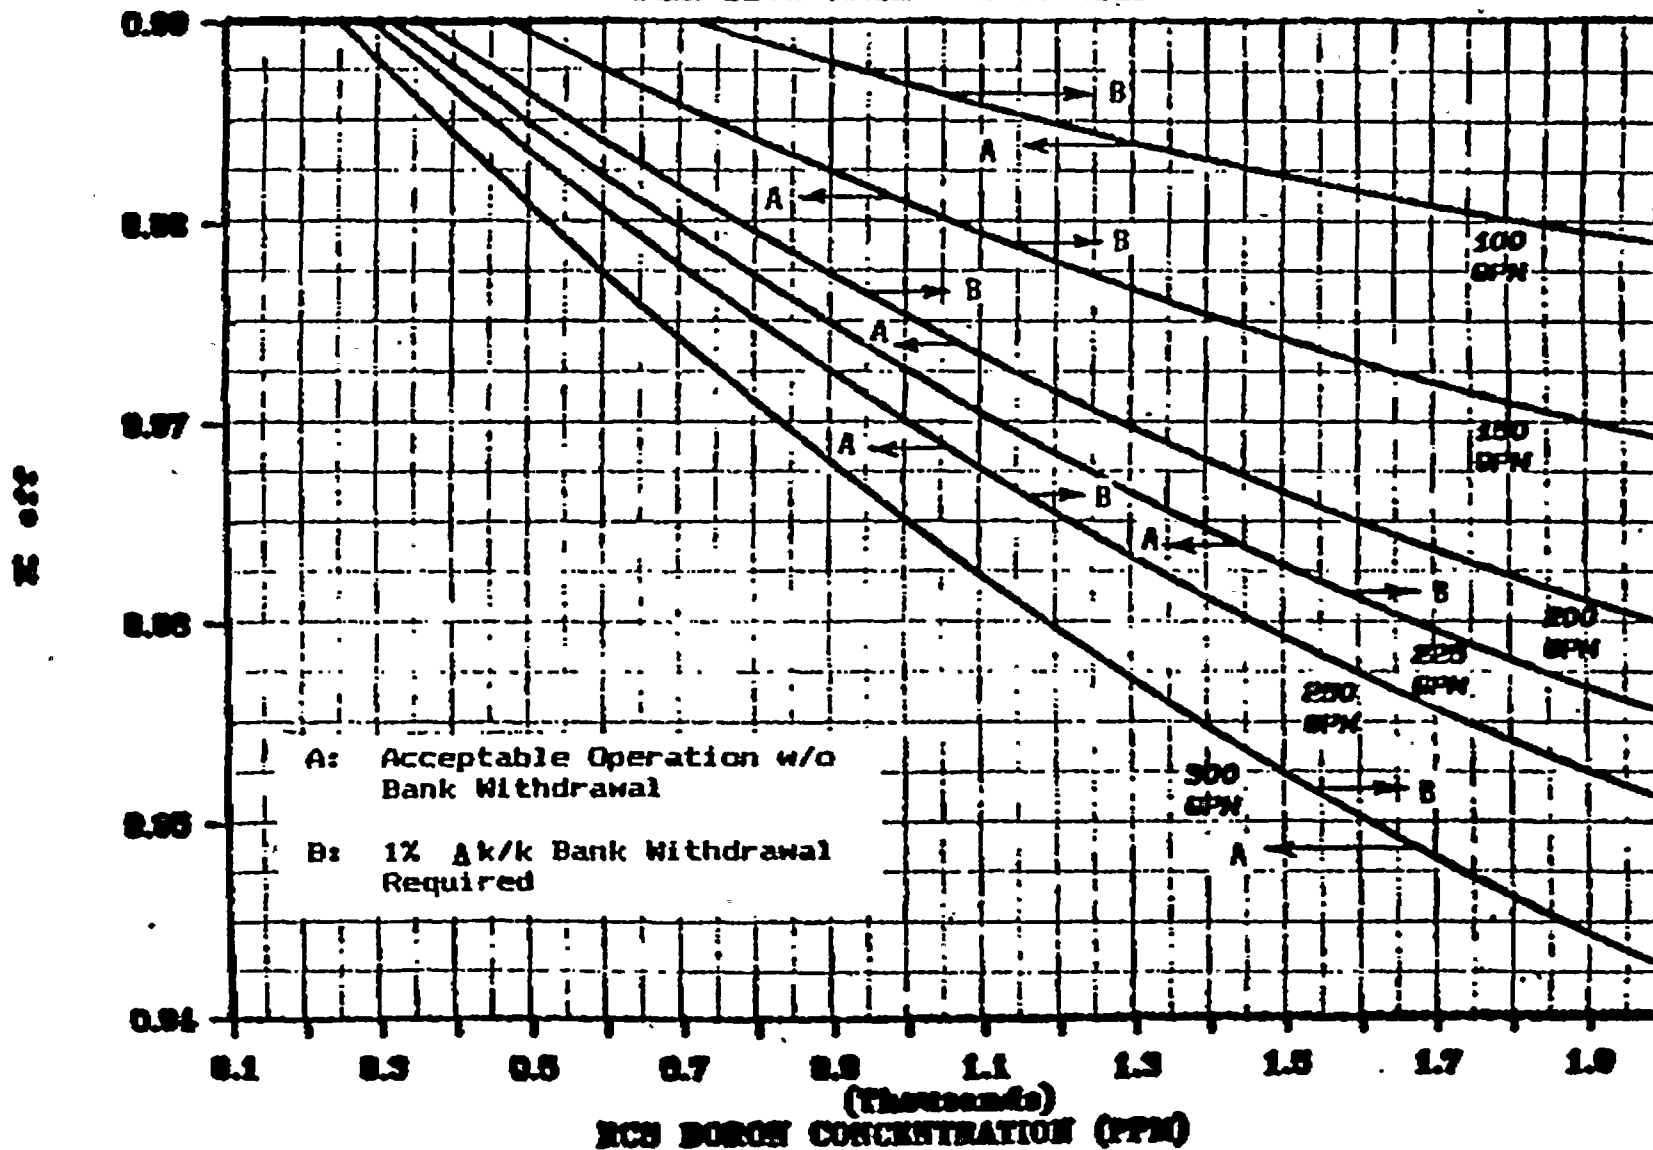
This attachment is divided into three parts. The first part entitled, "Revision of Figure A-1 of NS-TMA-2273" describes a new analysis for D. C. Cook Unit 1 similar to that described in the letter from T. M. Anderson to V. Stello dated July 8, 1980 (Identifier NS-TMA-2273). The analysis was performed by our contractor, Westinghouse Electric Corporation. The curve from this calculation which corresponds to our maximum dilution flow rate of 225 gpm was used to prepare Unit 1 T/S Figure 3.1-3, Required Shutdown Margin.

This discussion pertains to a revision of Figure A-1 provided in NS-TMA-2273. The scales of Figure A-1 have been extended to account for increased RCS boron concentrations Modes 4 and 5 (hot and cold shutdown). American Electric Power has indicated that the Mode 5 maintenance level minimum RHR flow rate is 2000 gpm. This is more limiting than the current minimum Mode 4 RHR flow rate of 3000 gpm. As such, the Mode 5 RHR flow rate of 2000 gpm was assumed for this revision. The maximum dilution flow rate is given as 225 gpm on page 14.C-21 (Unit 1) of D. C. Cook FSAR. The D. C. Cook Unit 1 plant specifics, as noted above, have been incorporated in the development of the revised curve.
